Addendum D1

re: **SB885F – Watershed & SB885 Bridge Apartment Interior Upgrade**
Indiana University South Bend
 IU Project #20250140

issue date: **April 1, 2026**

2 Bridge Second Floor Plan - Alternate #1
1/8" = 1'-0"

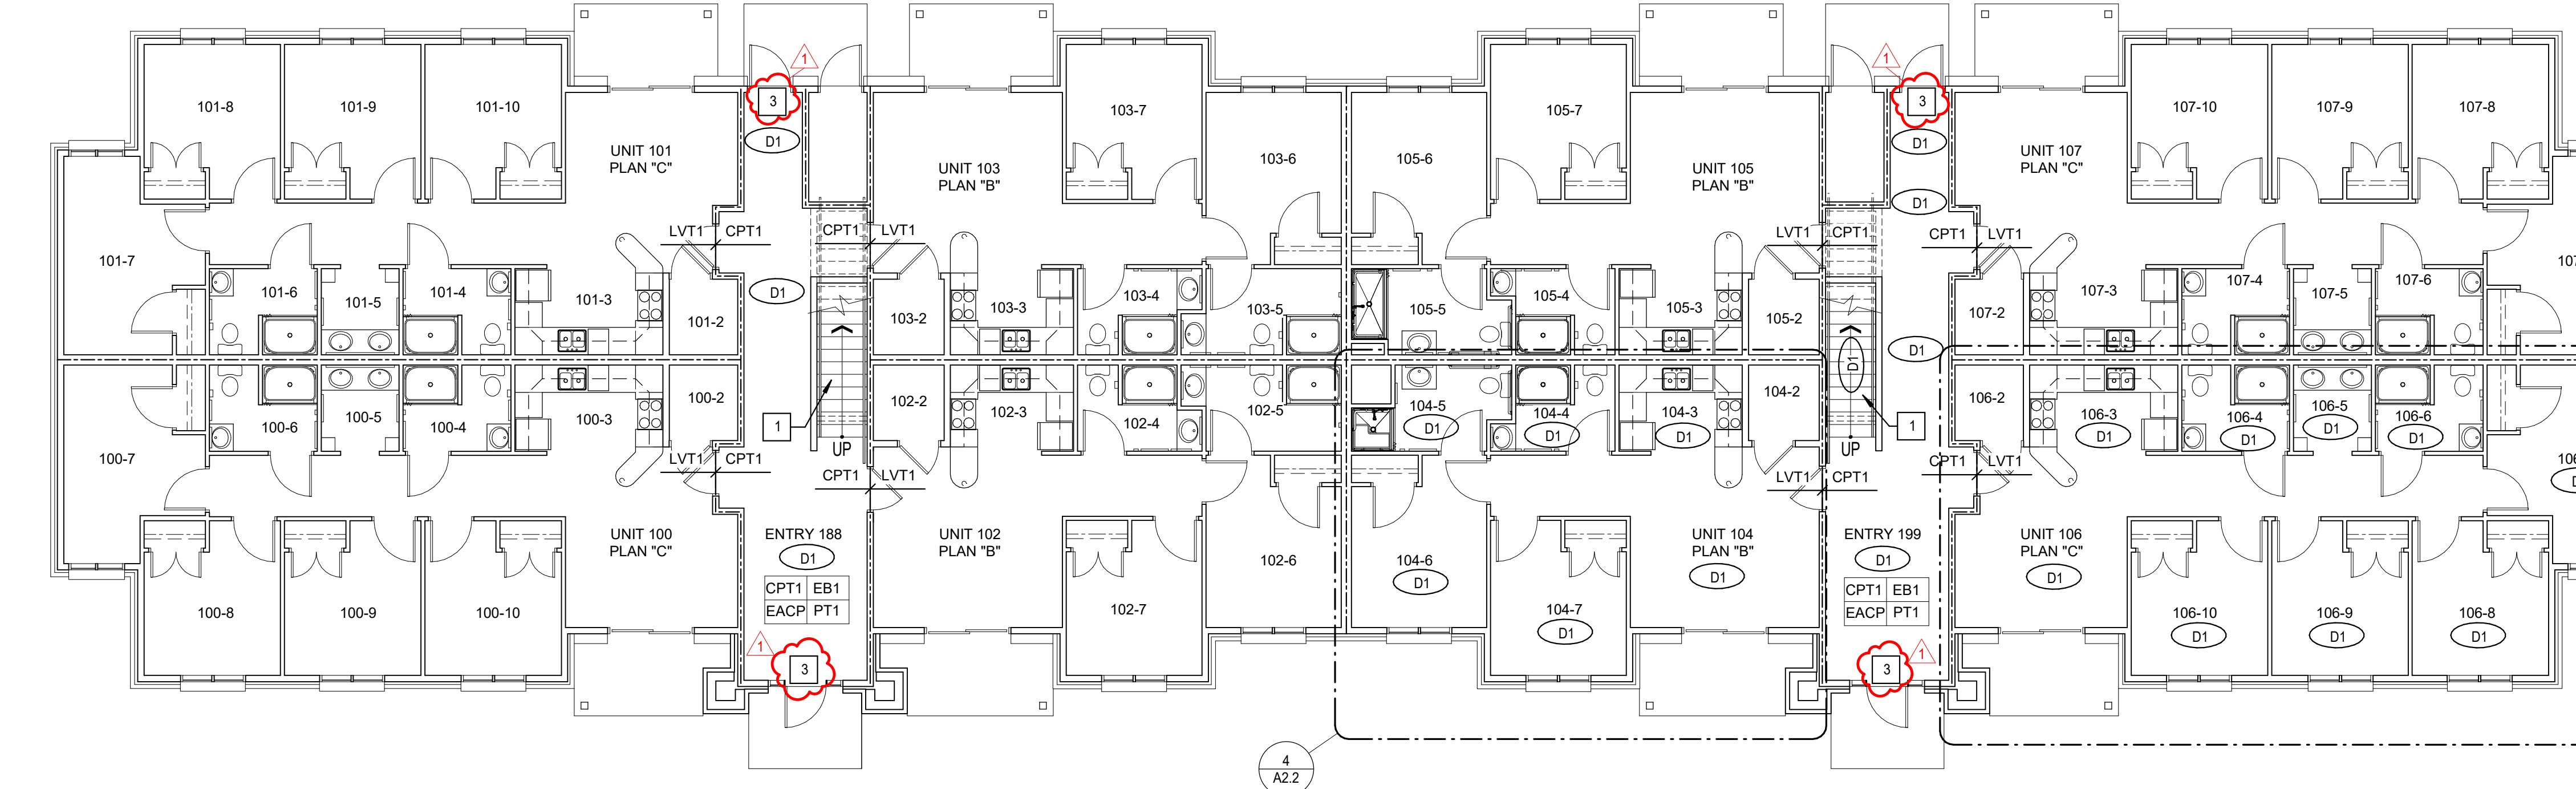
A1.08	DRAWING A2.2 (Drawing Reissued)	<u>ADD:</u> Sheet A2.2 reissued to add specific Floor Plan Note #18; to add Specific Finish Remark #3; and to add clarification on paint finish to receive enamel paint on exterior metal doors and frames.
-------	--	---

RST1 - JOHNSONITE	EACP - EXISTING ACOUSTICAL CEILING TILE
COLOR: #20 CHARCOAL WG *COLORMATCH	AND GRID TO REMAIN
FINISH: HAMMERED	
DOORS (UNIT PRICES 1, 2, 8, 12, 13 & 14)	
PT = PAINT COLOR	
PT1 - SHERWIN WILLIAMS	
COLOR: IVORY LACE	
NUMBER: SW7013	
FINISH: ENAMEL PAINT FOR EXTERIOR METAL	
DOOR & FRAMES
